MISSOURI RIVER
ST. JOSEPH, MO. TO FLORENCE, MO.
TOPOGRAPHIC SURVEY
MILE 654.9 TO MILE 655.3

In 72 Sheets Sheet No. 67

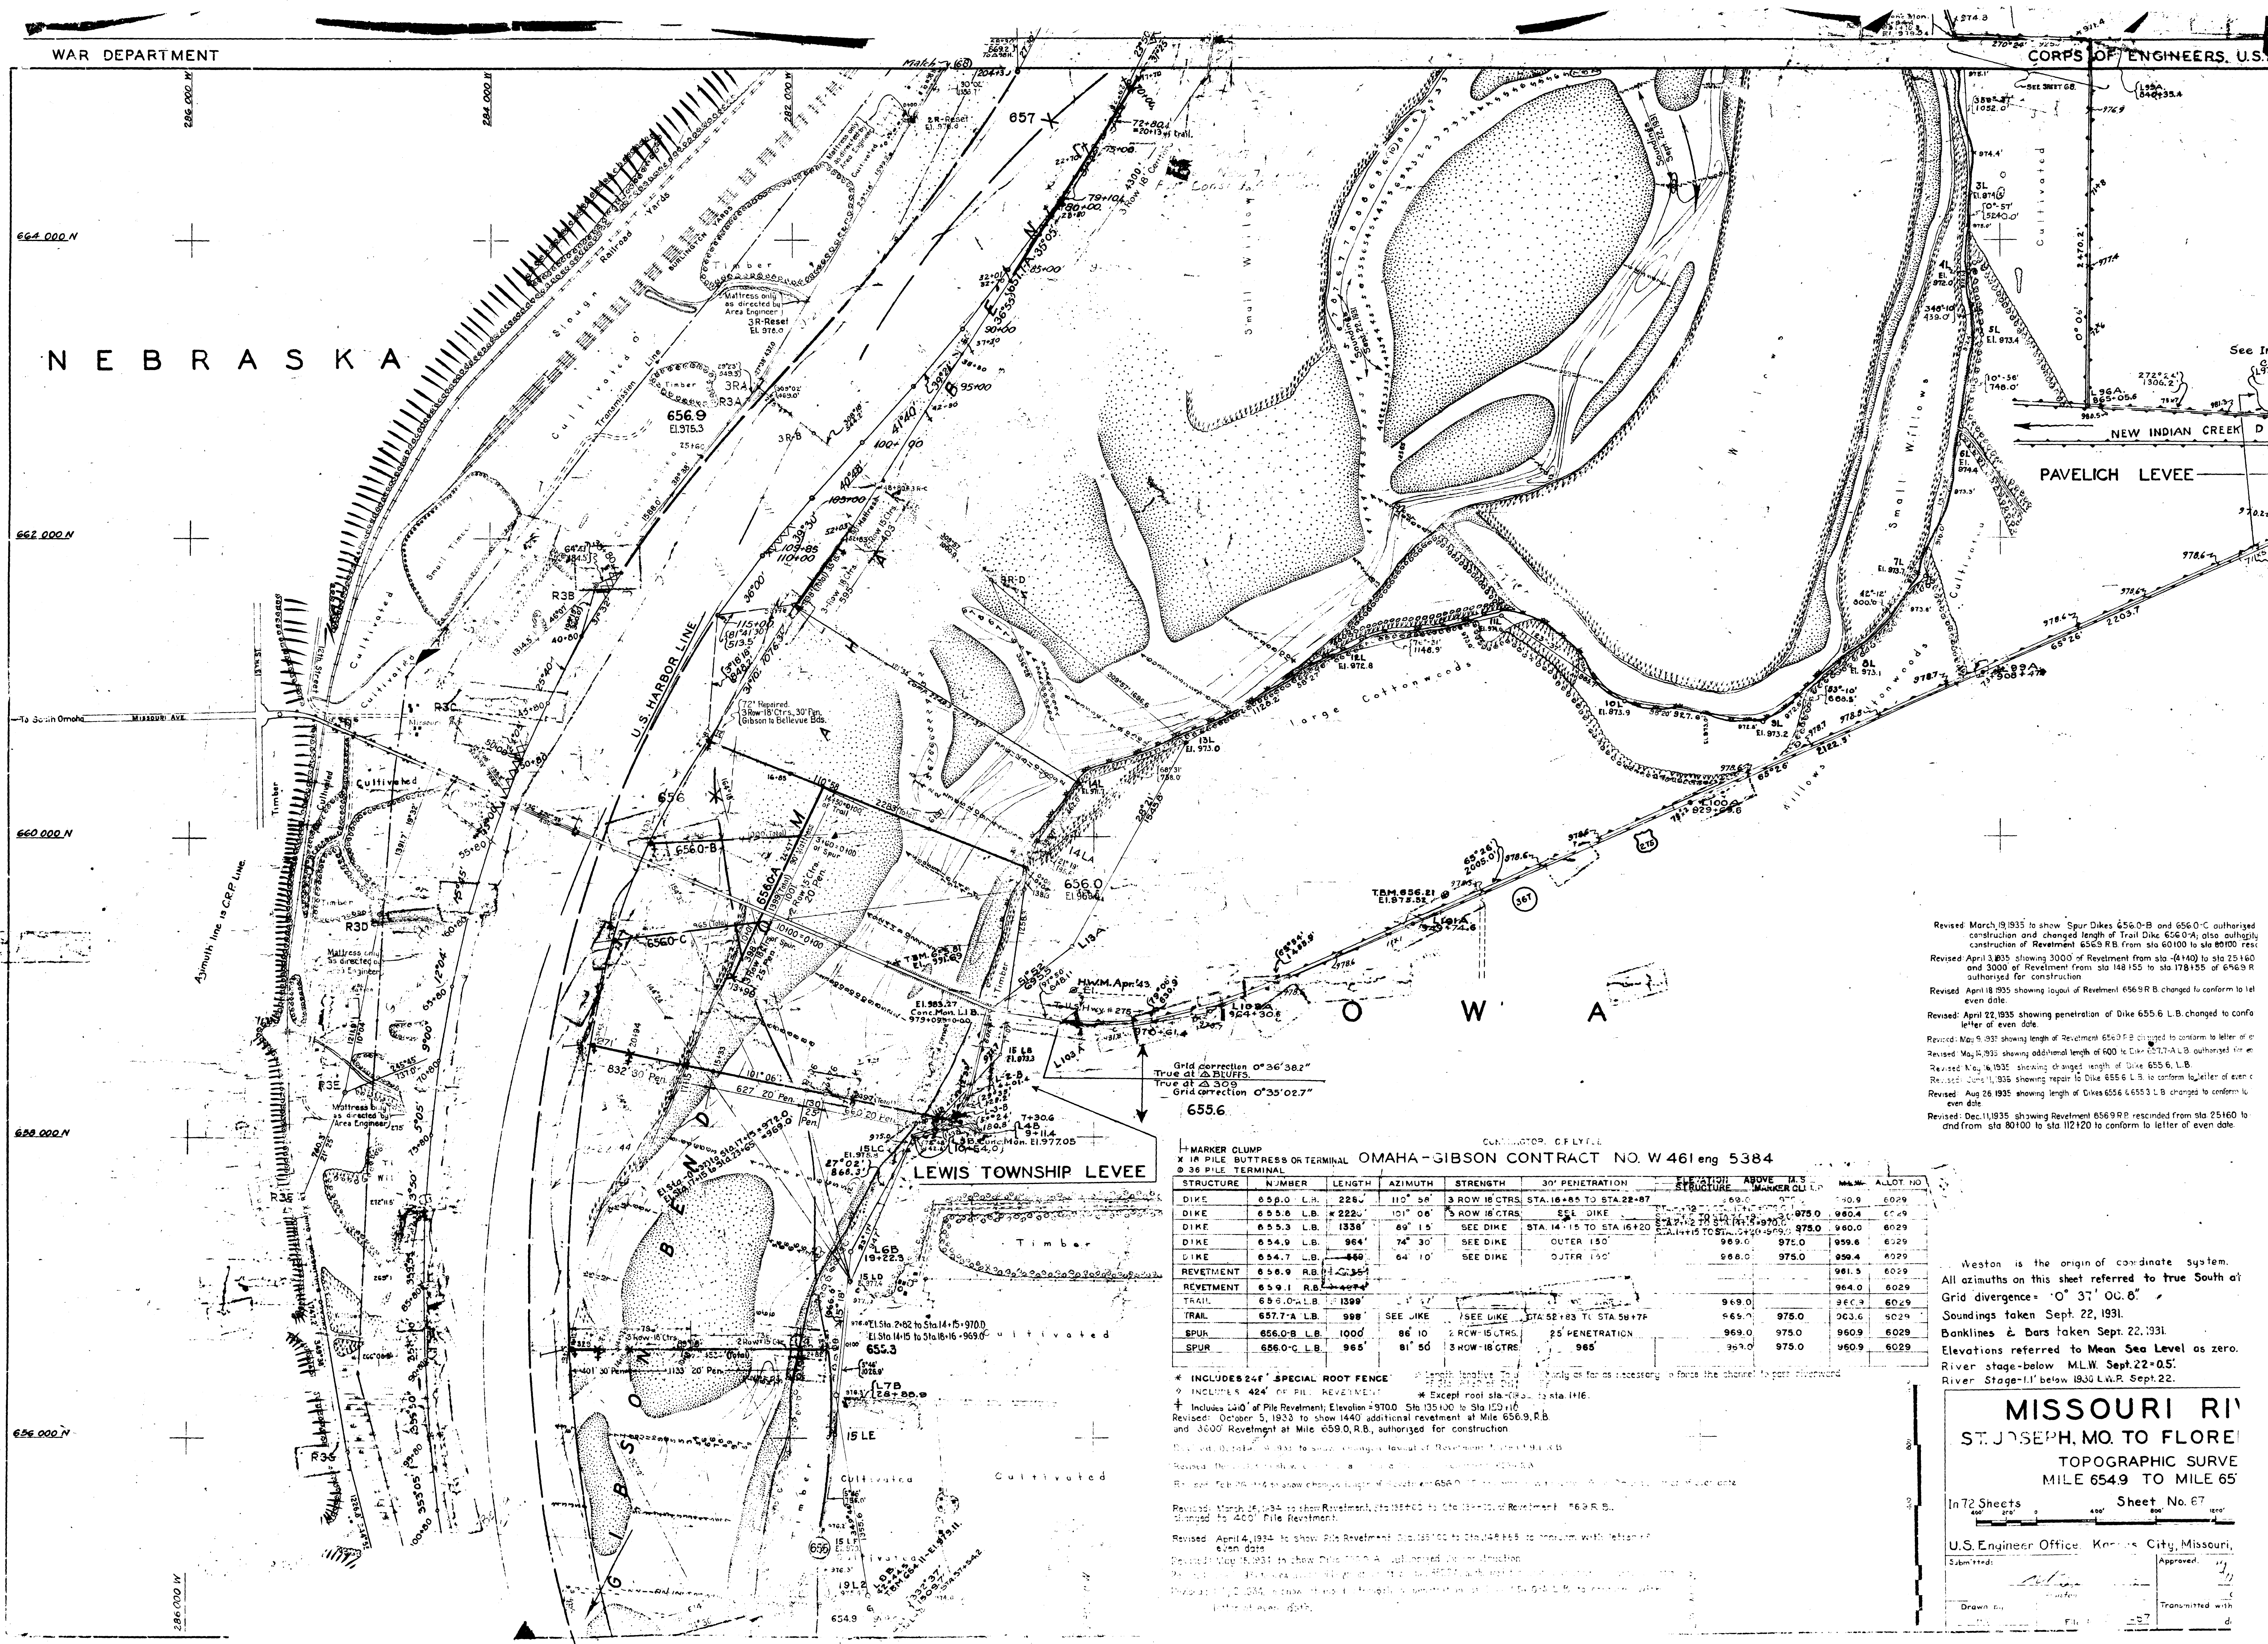
Revised March 19, 1935 to show Spur Dikes 656.0-B and 656.0-C authorized construction and changed length of Trail Dike 656.0-A; also authorized construction of Revetment 656.9 RB from sta 60100 to sta 80100 res.

Revised April 3, 1935 showing 3000' of Revetment from sta 41400 to sta 25160 and 3000' of Revetment from sta 18155 to sta 178155 of 656.9 authorized for construction.

Revised April 18, 1935 showing layout of Revetment 656.9 RB changed to conform to letter of even date.

Revised April 22, 1935 showing penetration of Dike 655.6 L.B. changed to conform to letter of even date.

Revised May 4, 1935 showing length of Revetment 656.9 RB changed to conform to letter of even date.

Revised May 19, 1935 showing additional length of 600' to Dike 655.6 L.B. authorized for construction.

Revised May 19, 1935 showing changes in length of Dike 655.6 L.B.

Revised June 11, 1935 showing repair to Dike 655.6 L.B. to conform to letter of even date.

Revised Aug 25, 1935 showing length of Dikes 655.6 L.B. changed to conform to letter of even date.

Revised Dec 11, 1935 showing Revetment 656.9 RB resited from sta 25160 to sta 80100 to conform to letter of even date.

Revised: October 5, 1933 to show 1440 additional revetment at Mile 656.9, R.B. and 3000' Revetment at Mile 659.0, R.B., authorized for construction.

Revised: October 10, 1933 to show changes in layout of Revetment 656.9 RB.

Revised: March 16, 1934 to show Revetment, Sta 18155 to Sta 178155 of Revetment 656.9 RB, changed to 400' Pile Revetment.

Revised: April 4, 1934 to show Pile Revetment Sta 18155 to Sta 178155 to conform with letter of even date.

Revised: May 19, 1935 to show Dike 655.6 L.B. authorized for construction.

Revised: June 11, 1935 showing repair to Dike 655.6 L.B. to conform to letter of even date.

Revised: Aug 25, 1935 showing length of Dikes 655.6 L.B. changed to conform to letter of even date.

Revised: Dec 11, 1935 showing Revetment 656.9 RB resited from sta 25160 to sta 80100 to conform to letter of even date.
